POINT BEACH NUCLEAR PLANT, UNITS 1 AND 2
DOCKETS 50-266 AND 50-301
REACTOR VESSEL CLOSURE HEAD PENETRATION REPAIR
RELIEF REQUESTS MR 03-018-1 AND MR 02-018-2
SUPPLEMENT 2 AND RESPONSE TO REQUEST FOR ADDITIONAL INFORMATION

**RESPONSE TO REQUEST FOR ADDITIONAL INFORMATION (RAI)
REGARDING RELIEF REQUEST SUBMITTALS MR 02-018-1 AND MR02-018-2
DATED AUGUST 23, 2002 AND APRIL 10, 2003**

POINT BEACH NUCLEAR PLANT, UNITS 1 AND 2

Figure 1. Weld Anomaly in Temper Bead Weld Repair

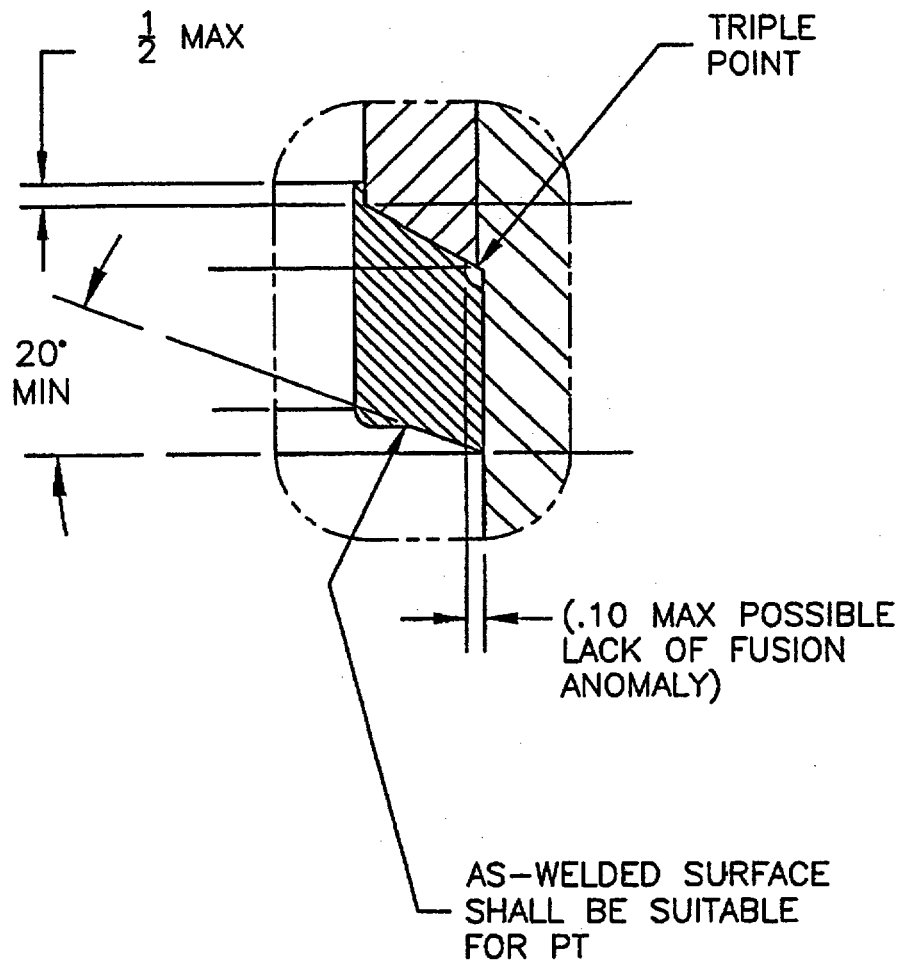
In your April 10, 2003 letter responding to the staff's RAI, in calculation summary sheet 32-5019398-00, PB-1 CRDM Nozzle IDTB Weld Anomaly Flaw Evaluations, page 4, the statement is made: "This weld repair establishes a new pressure boundary above the original J-groove weld, except in some cases away from the center of the head where the new weld partially overlaps the original weld."

Recent experience at ANO-1 and North Anna, where weld repairs cracked at the junction of the Alloy 52 and Alloy 182 boundary after one cycle of operation have come to light. Taking into considerations the lessons learned from this occurrence, please discuss the actions that will be taken in the area of monitoring the repair for structural and leak integrity when the new repair weld overlaps the remnant J-groove weld.

The intended service life of this proposed repair is one fuel cycle. The possible overlap that may occur on a repair will not constitute the entire length of the new Alloy 52 weld. Using a conservative confluence of minimum tolerances there will be a satisfactory ligament where the new Alloy 52 weld does not overlap the old Alloy 182 weld and is attached to the low-alloy steel RV head. The actual length of the overlap will be minimized by taking field measurements of RV head thickness and J-groove weld depth instead of using the conservative tolerance values.

The potential for a preexisting flaw to propagate along the boundary between the new Alloy 52 and the low alloy steel (first pass diluted zone) has been considered and is described below.

There have been numerous repairs of Alloy 600 locations in U.S. PWRs using Alloy 52. Many of these repairs resulted in the interface between low alloy steel and an Alloy 52 weld being exposed to primary coolant (examples include 150+ CE PZR nozzle repairs, FRA-ANP's CRDM IDTB process, miscellaneous hot leg and PZR instrument nozzles). Extensive industry operating experience has shown Alloy 52 to be highly resistant to PWSCC, without any such 1st diluted layer cracking as described above. The actual geometry of the overlap in the Point Beach CRDM repair is expected to result in a low crack driving force in the 1st diluted layer due to the small size (~0.070") of such a layer and restraint by surrounding materials. Also, the Alloy 52 weld is applied with an ambient temperature temperbead GTAW process, which minimizes the residual tensile stresses contributing to the crack driving force.

In addition to the evidence described above, the proposed repair weld will have its structural leak integrity verified by volumetric NDE, thereby giving assurance of no pressure boundary leakage.
